NA HOMES Subdivsion: NCOR **PURCHASER REQUEST FOR EXTRAS** Elevation Purchaser Res. No. Date Required Bus. No. Date Ordered

STRUCTURAL REQUIREMENTS*

MESSARA

BASEMENT

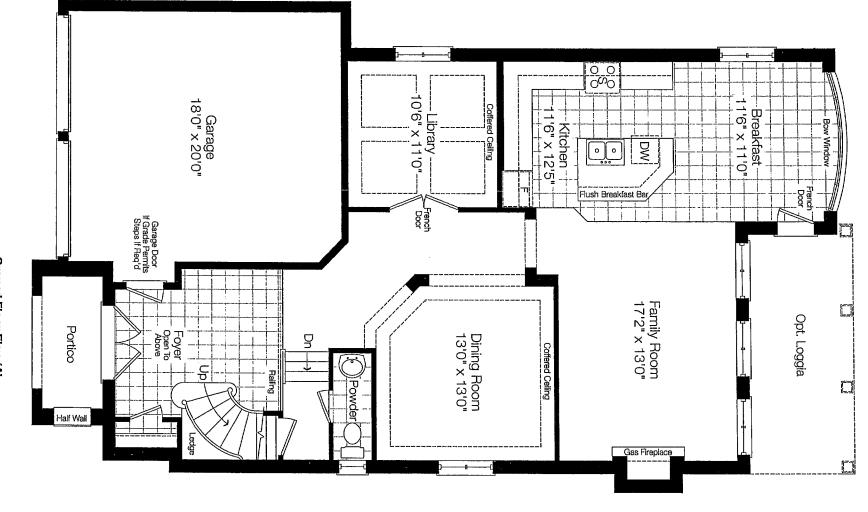
| AT | | | Ma | | (7) Den | | | n | | 16) | W | 0 | |) () | (1) (1) (2) | | |
|---------------------------------|-------------|---------------|------|---------------|----------------|---------|----------------|-----------------|-----------------|----------------|-----------|---------------|------------|----------------|--------------|---------|--|
| COLOR CHART TIME TOTAL AMOUNT > | | BONUS (ASPER | Moon | to toilet inm | nove April nil | Arver / | n Pièce Motana | rates quite sur | hower 10 day 10 | hamellas) alos | indow (1) | mlarge basens | 4"H × 30"W | whole above to | alway the en | asement | |

Second Floor Elev. 'A'

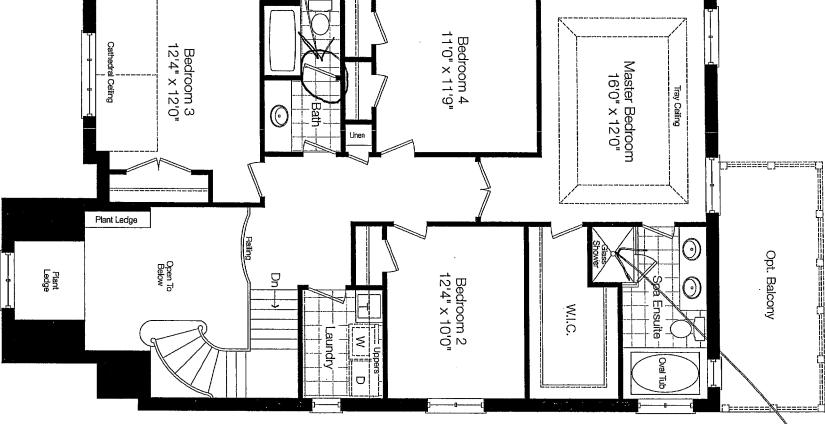
MALL

REMOVE
